2025 WSE1 ENU

# WSE1- Rework Rear Inner Left and Right Side Section (Workshop Campaign)

Vehicle Type: Taycan Turbo GT with Weissach package (Y1AFP1)

Installation position of seal weld

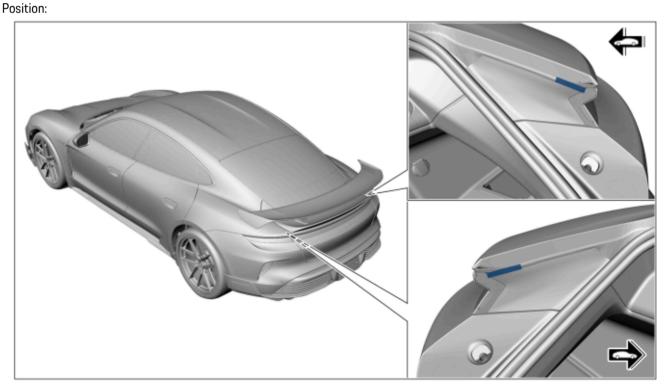
Cause: The Taycan Turbo GT with Weissach package does not come with a rear lid closure as standard. In combi-

nation with the additional weight of the rear spoiler, increased force can therefore be exerted on the sealing

seam in the area of the rear lid during manual closing. This could damage the sealing seam.

Action: Rework rear inner left and right side sections.

Removal area of the sealing seam

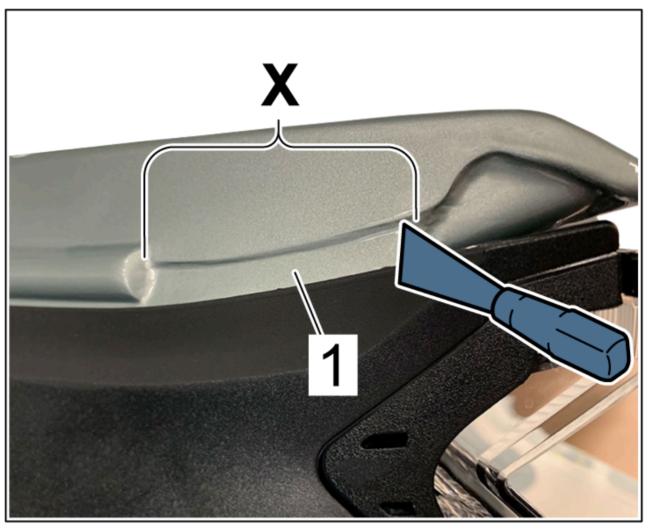
2 Carefully remove approx. **60 mm / 2.40 in** ⇒ Removal area of the sealing seam **-X**- from the folding edge of the rear light corner ⇒ Removal area of the sealing seam **-1**- using a scraper such that the coating of the metal surface is not damaged.

Make sure that the length of the existing sealing seam is identical  $\Rightarrow$  Rework is OK -1 - on both sides after removal.

Sealing seam on the rear side section on the inner right

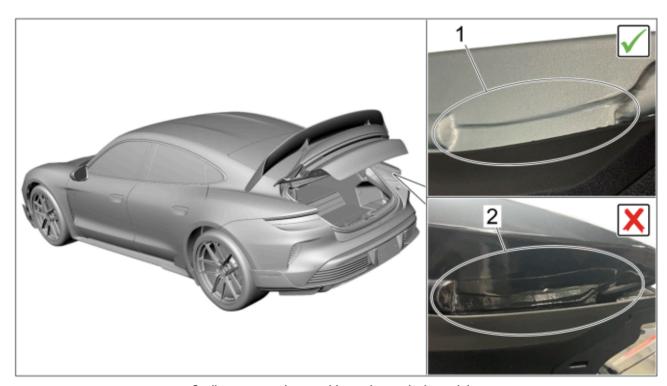
(√)	The reworking area $\Rightarrow$ Sealing seam on the rear side section on the inner right -1- is clean and there are no residues of the sealing seam; the rework is <b>OK</b> .
(X)	Sealing seam residues $\Rightarrow$ Sealing seam on the rear side section on the inner right -2- are still visible in the rework area; rework is <b>not OK</b> here.
